Project Address: 2620 Monroe Street & 665 Knickerbocker Street
Application Type: Demolition Permit and Conditional Use
Legistar File ID # [30334](#)
Prepared By: Timothy M. Parks, Planning Division
Report includes comments from other City agencies, as noted.

Requested Action: Approval of a demolition permit and conditional use to allow demolition of an auto repair shop at 2620 Monroe Street and a single-family residence at 665 Knickerbocker Street and construction of a mixed-use building containing approximately 2,300 square feet of first floor retail space and 21 apartments.

Figure J-5: Street Section Diagram

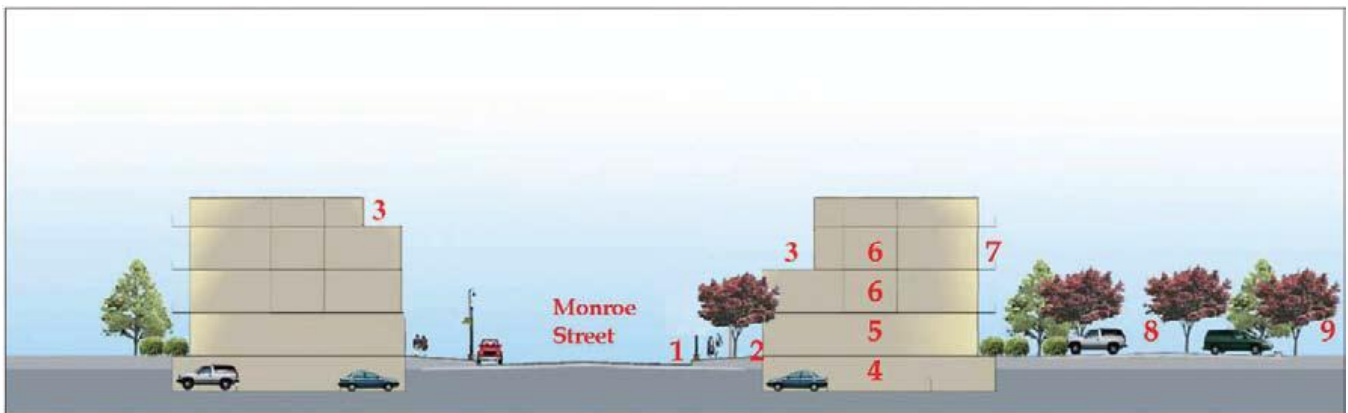
Figure J-5 represents a prototypical application of some of the general design guidelines for a mixed-use building with ground floor retail and residential uses above. The diagram portrays a building constructed up to a build-to line (1), with setbacks permitted for sidewalk cafes or other outdoor seating areas (2). Top floor setbacks from the main facade line is shown a (3) on the diagram. Retail/commercial uses (5), residential uses (6), and parking located underground or within building (4) are as shown. Residential balconies are encouraged (7), including those located along the rear of new buildings. Area (8) calls for landscaped parking and service areas screened and at the rear of the site.

Planning staff believes that the proposed mixed-use building conforms to most of the design standards and guidelines contained in the Monroe Street Commercial District Plan. The new building adheres to the building placement, orientation, and architectural recommendations in the plan, including the transition in the rear to the residential neighborhood to the north.
